PCN

Change of packaging for EPCOS PQ 35/35 ferrite cores

Product / Process Change Notification

1. ID No.: MAG-515020718		2. Date of announcement: July 13, 2018	
3. Product / product group: EPCOS ferrite cores PQ 35/35	Old ordering code: B65881A0000R049	New ordering code: No change	Customer part number: No change
	B65881A0160A049		
	B65881A0000R087		
	B65881A0000R092		
	B65881A0000R095		
	B65881A0000R097

Enclosure PCN (ID No. MAG-515020718)
Dimensional drawing of new EPS tray

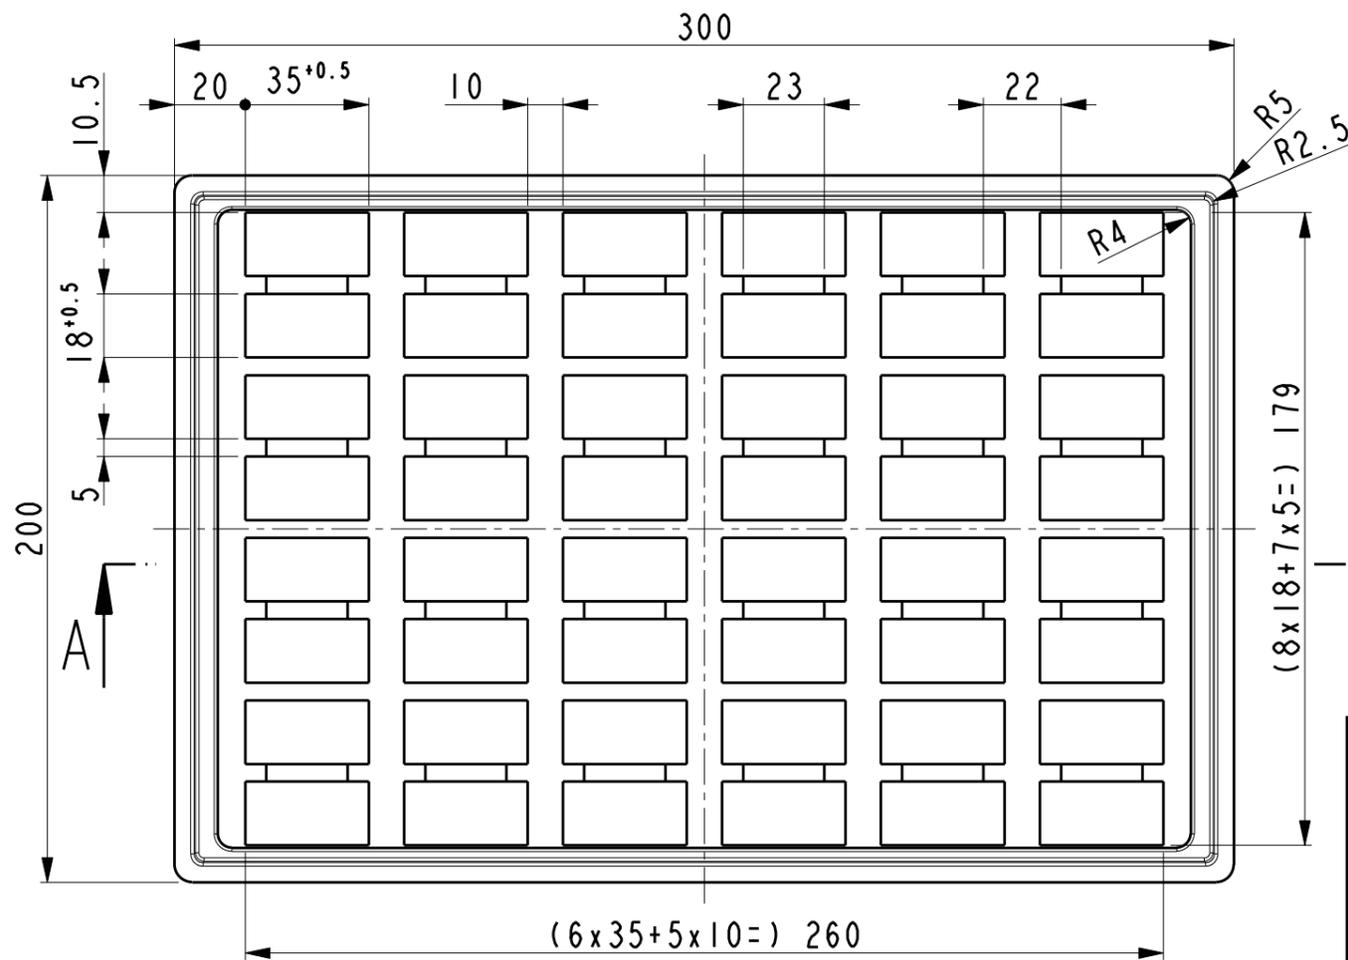
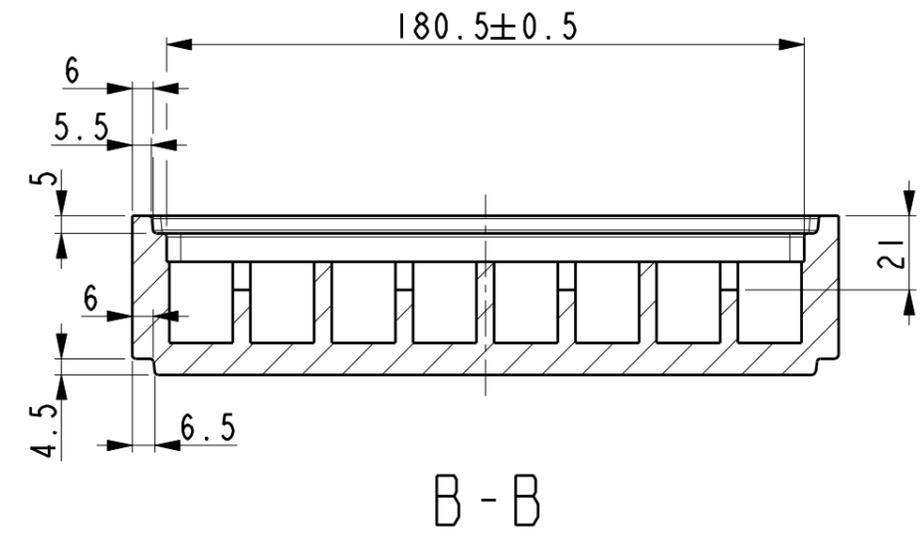
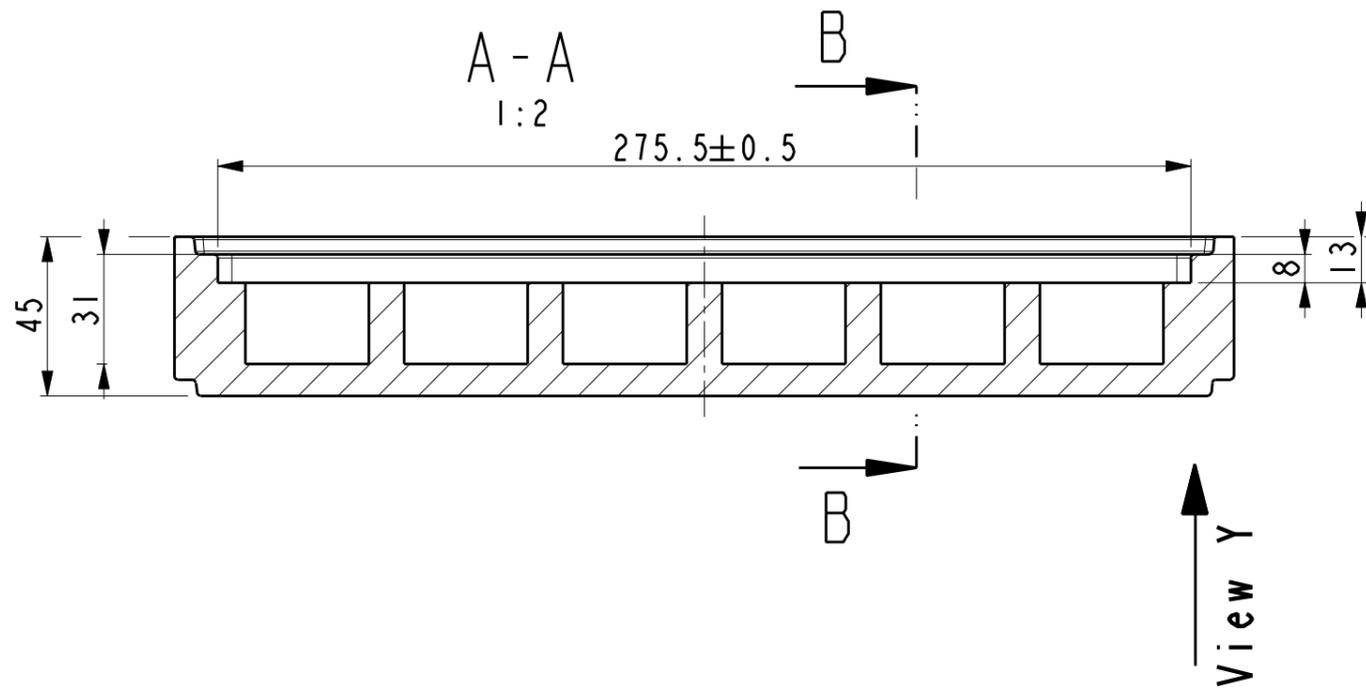
4. Description of change: Change of EPS tray packaging: New packaging: EPS tray V885 with separate cavity for each core. Total height = 45 mm (see enclosure). Old packaging: EPS tray V449 with 4 cores per cavity. Total height = 30 mm.

5. Effect on the product or for the customer (benefit, quality, specification, lead time): The separate cavity for each core prevent any contact between the cores and therefore chipping at the edges of the cores.
